*Proceedings of the Madras Government, Public Works Department,
5th February 1876.*

SENATE HOUSE, MADRAS.

INDENT FOR MAREZZO MARBLE SPANDRILS.

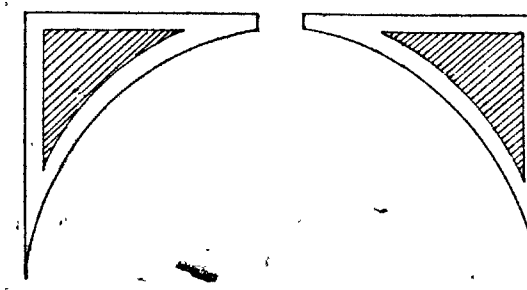
2. Are the spandrils intended to be made all to one hand as shown on the diagram accom-
panying indent, or are they required to be made in pairs, right and left hand, thus?

The spandrels are to be made in pairs right and left.

Cross sections of spandril.

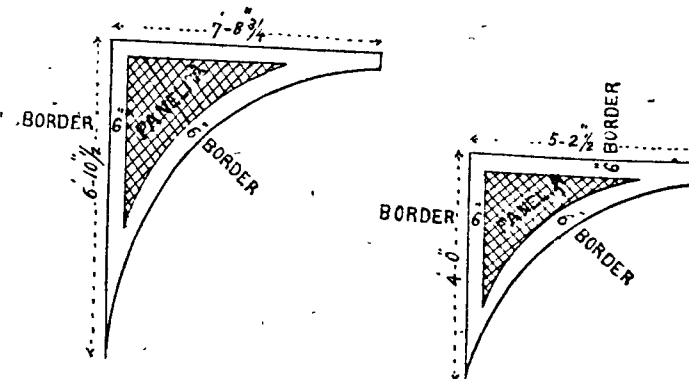
3. Is it intended that the panel A should be flush with the border as shown at B, or should
it be recessed back from the border as shown at C, and, if so, how much?

The panel should be flush throughout affording no ledge for moisture to rest on.

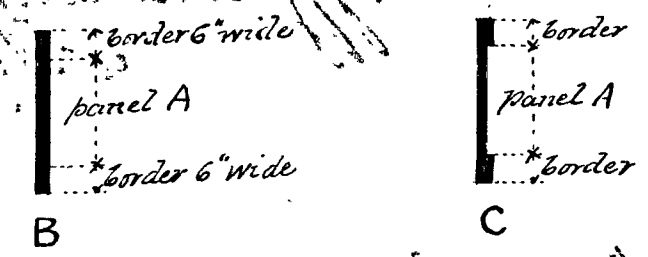
1. It is presumed the Marble is intended to be used for internal decoration, as it is believed that it is useless for external work.
2. Are the Spandrels intended to be made all to one hand as shown on the diagram accompanying incident or are they required to be made in pairs, right and left hand thus?

The spandrels are to be made in pairs right and left.

Cross Sections of Spandrel.

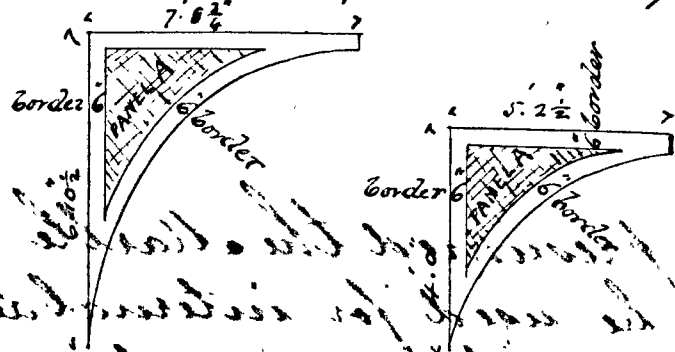
3. Is it intended that the panel A should be flush with the border as shown at B, or should it be recessed back from the border as shown at C, and if so. how much?

The panel should be flush throughout affording no ledge for moisture to rest on.
